ADDRESS: 108, 109, 110, 112, 114, 115, 125, AND 127 N MOLE ST

Proposal: Construct rear additions; restore front facades

Review Requested: Final Review

MOLE ST RENOVATIONS

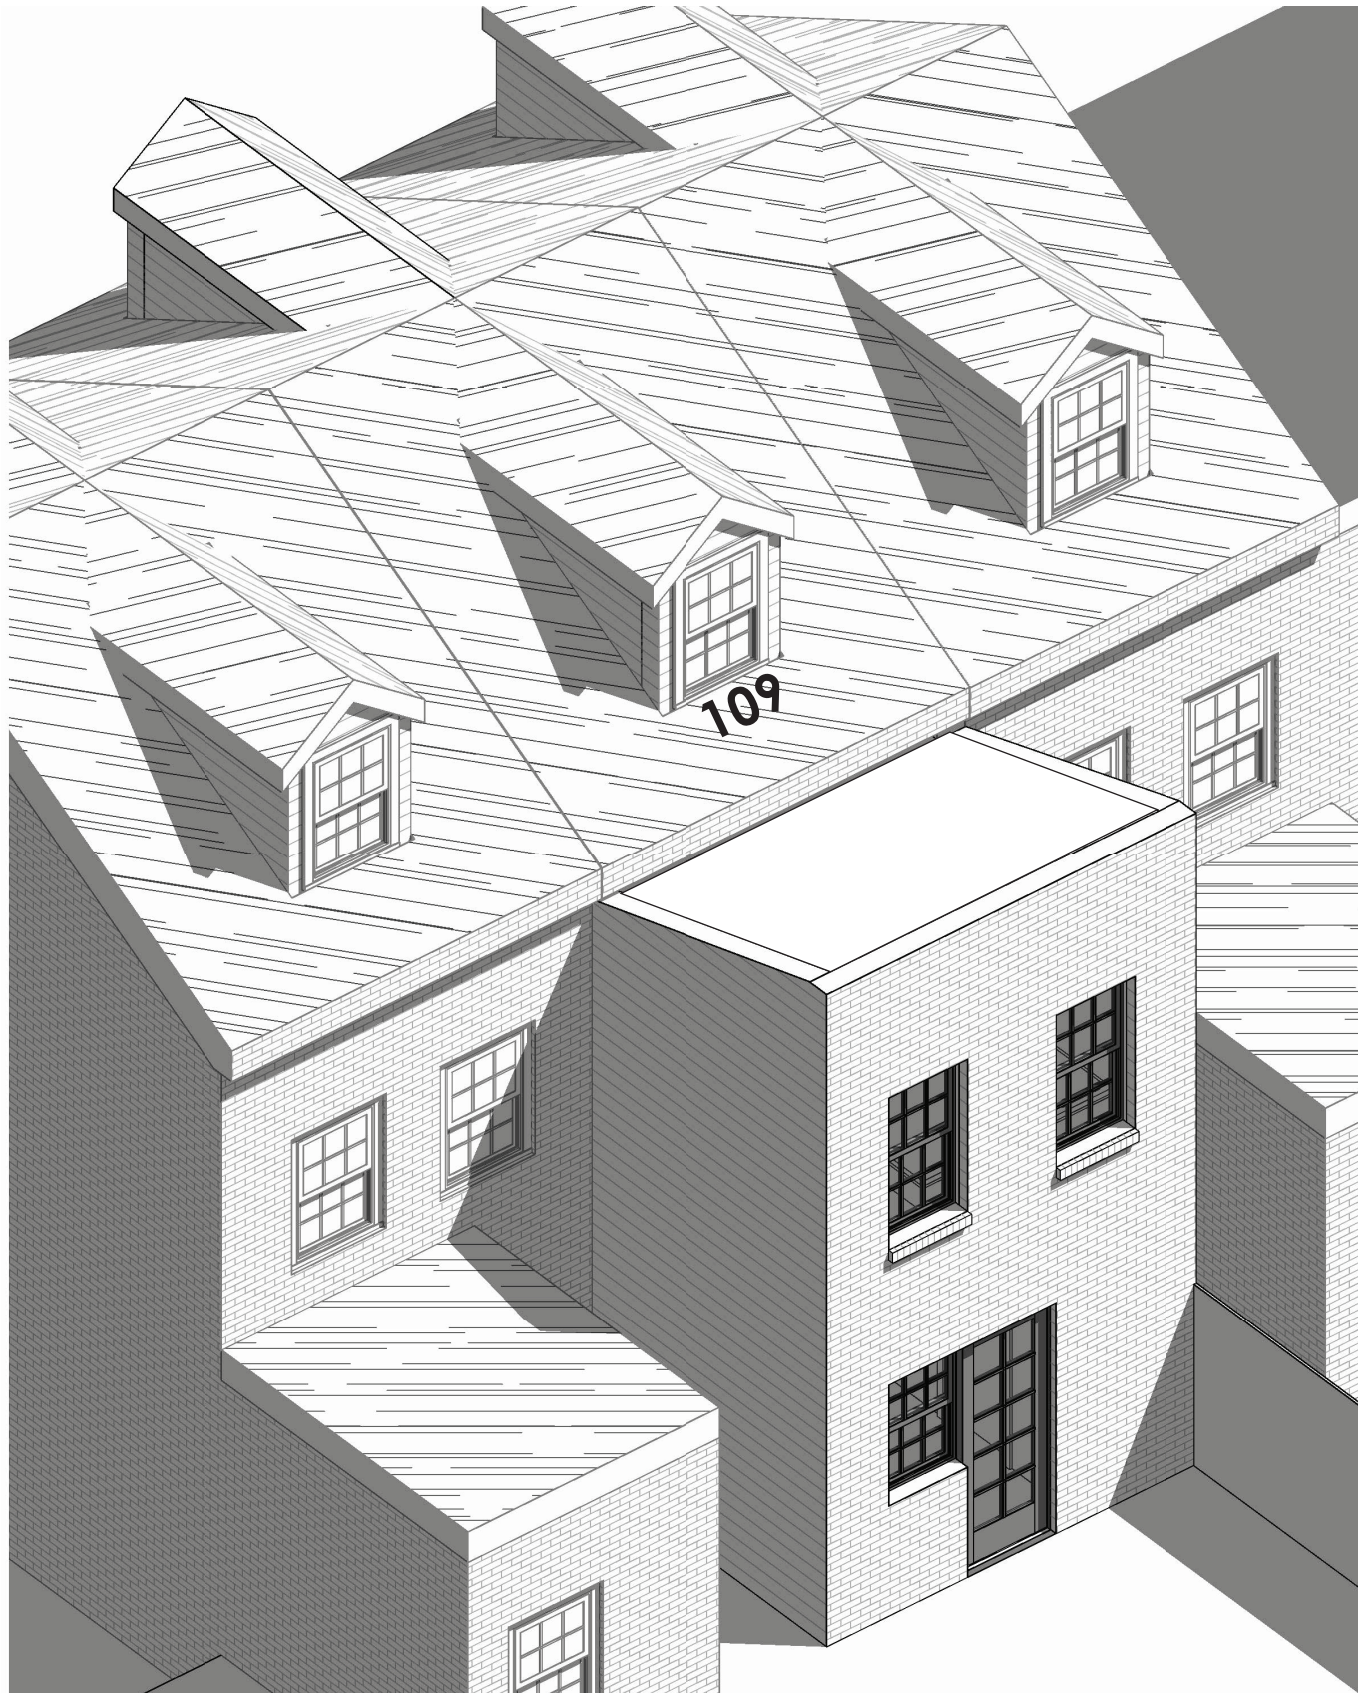
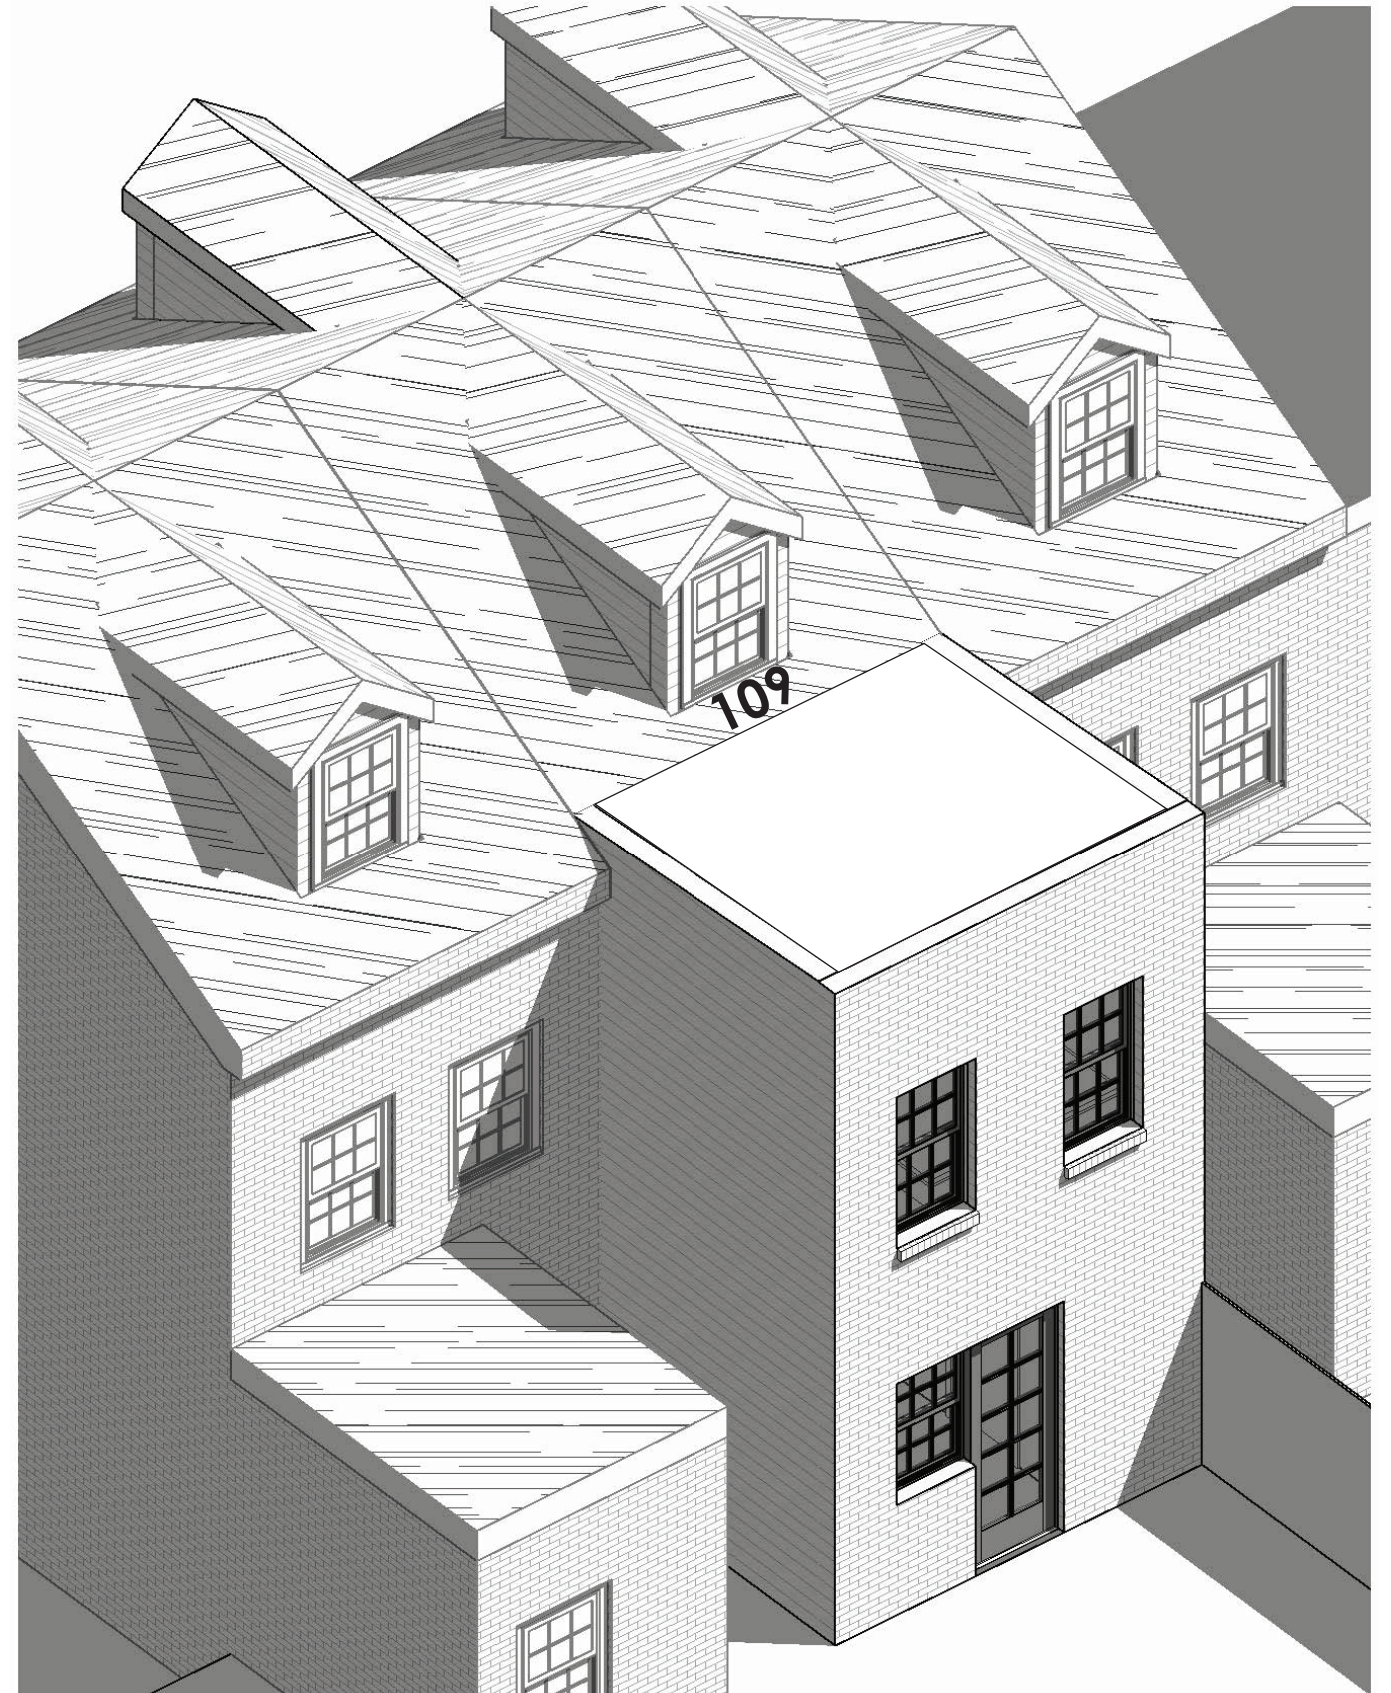
PREVIOUSLY PROPOSED

SUPPLEMENTED

BASED ON ARCHITECTURAL COMMITTEE COMMENTS

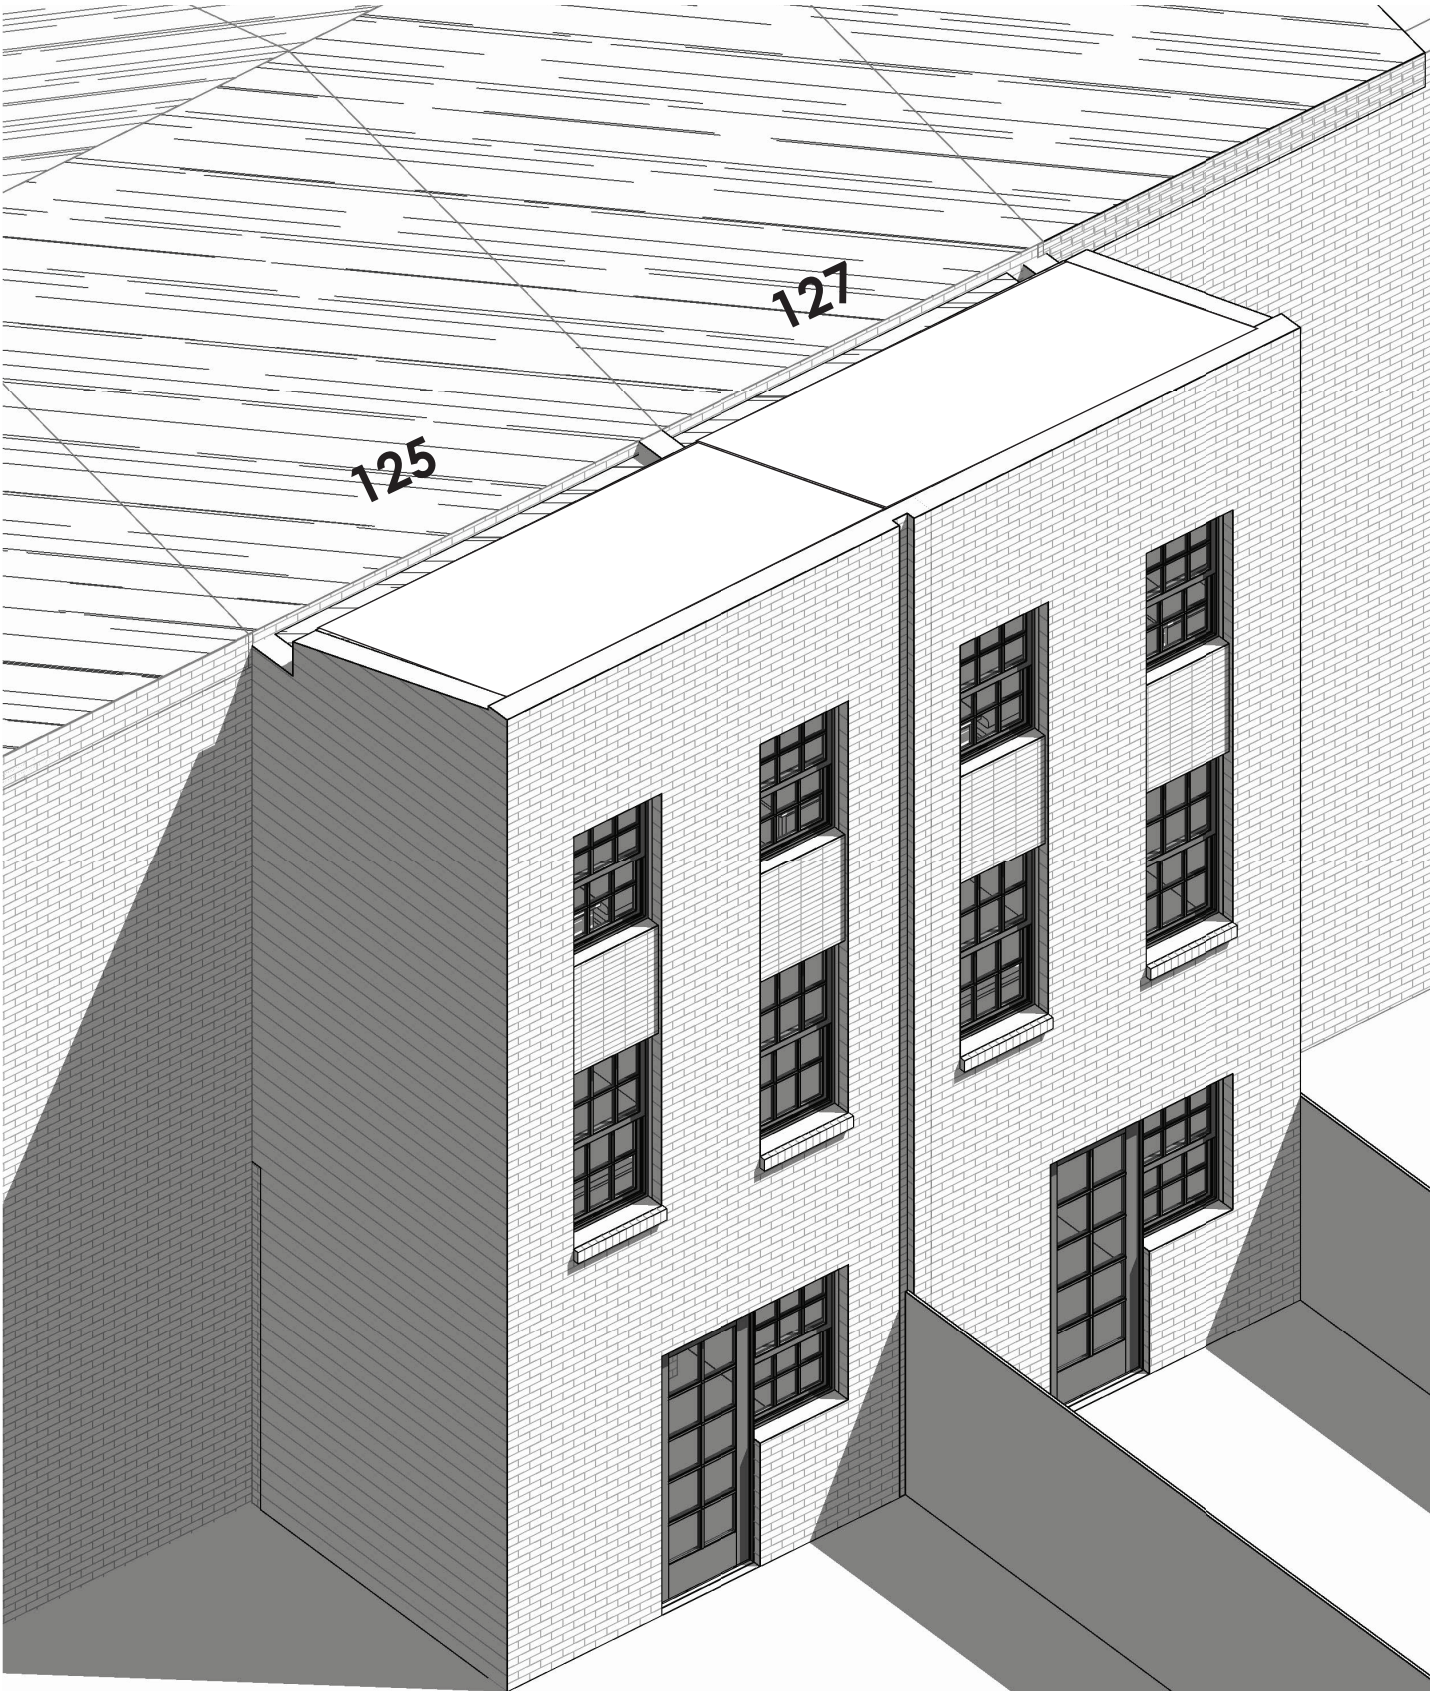
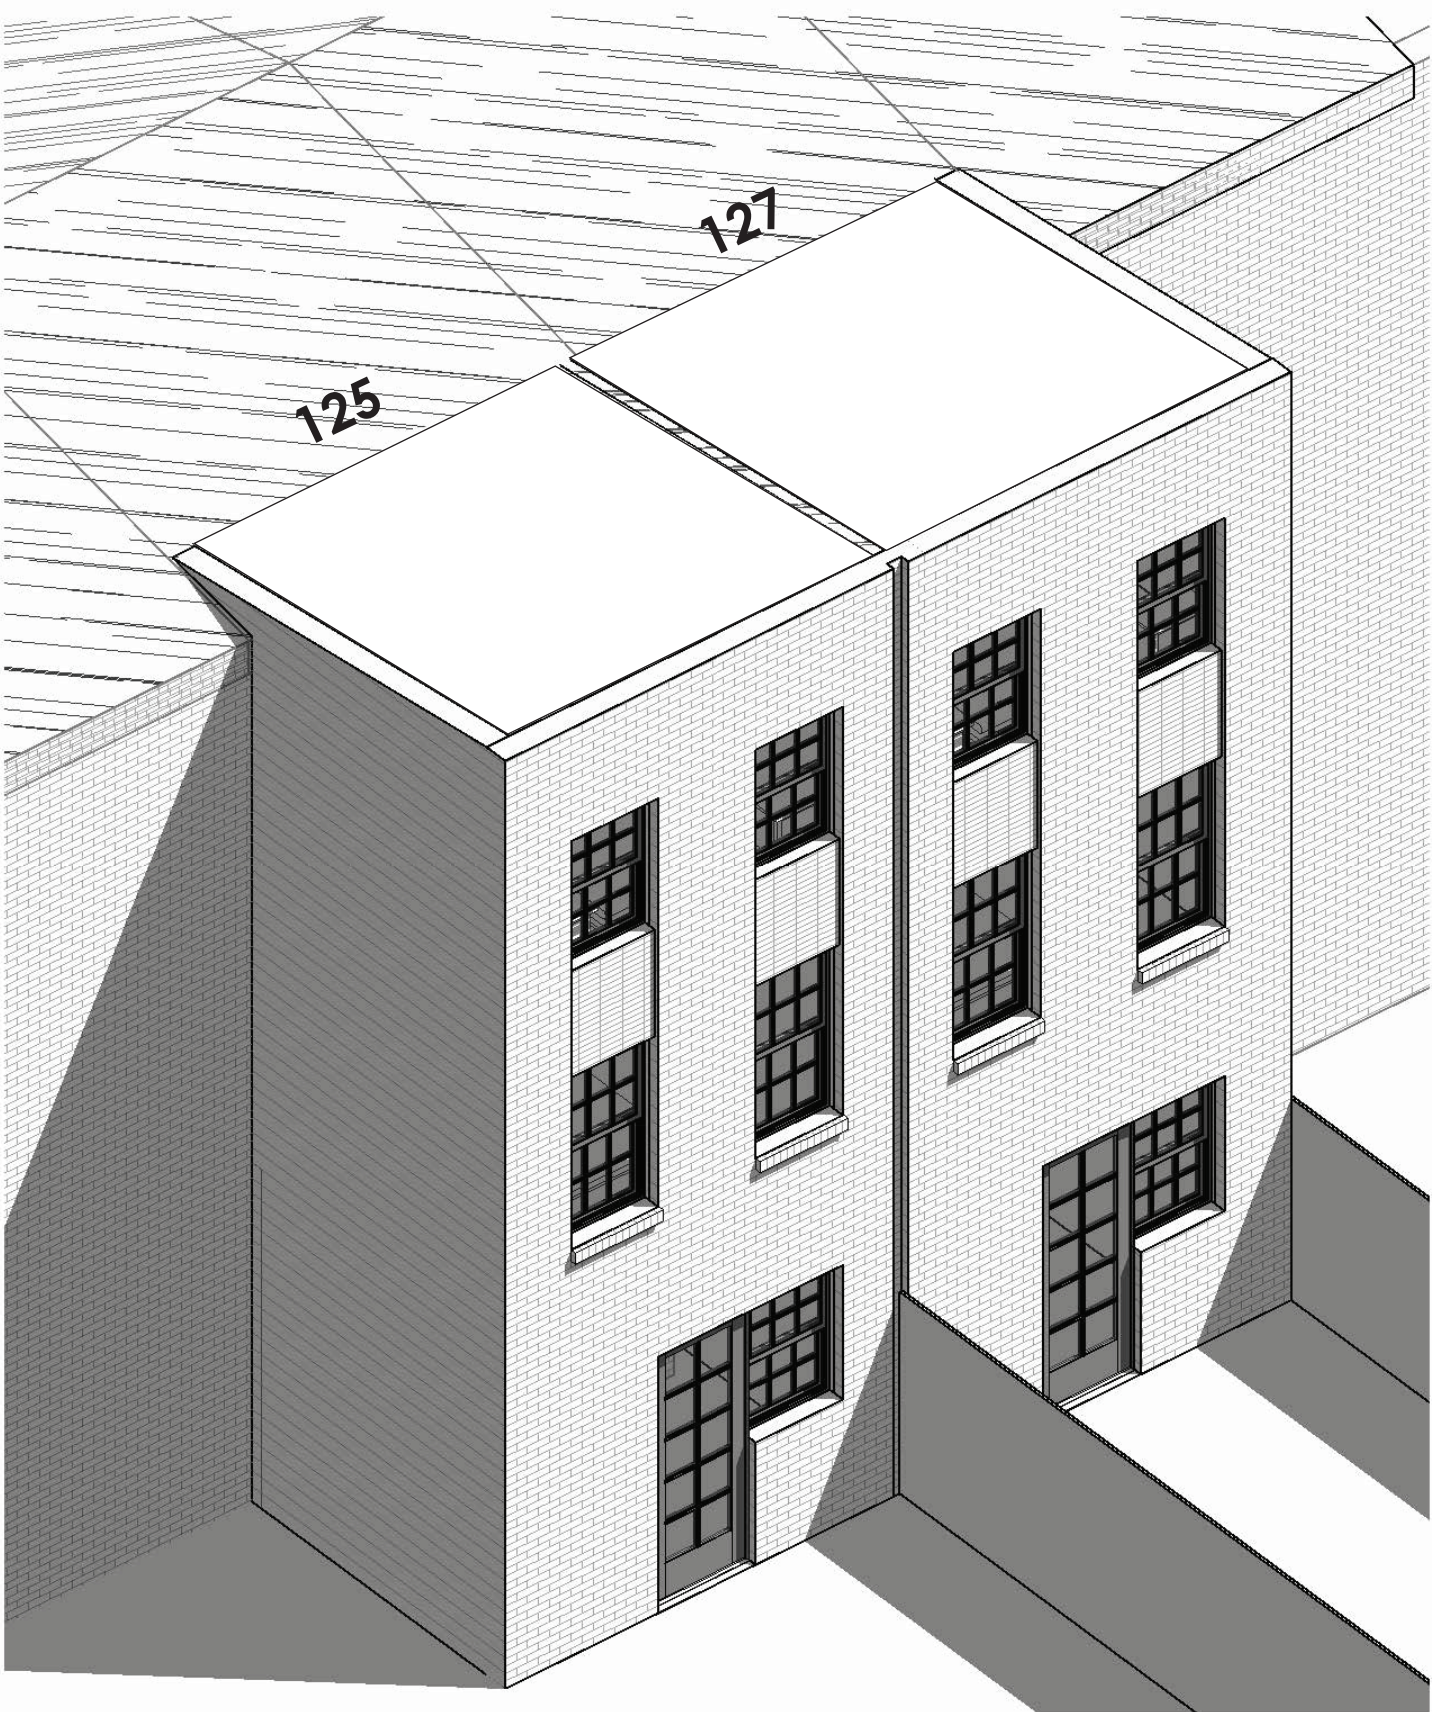
PREVIOUSLY PROPOSED

SUPPLEMENTED

BASED ON ARCHITECTURAL COMMITTEE COMMENTS
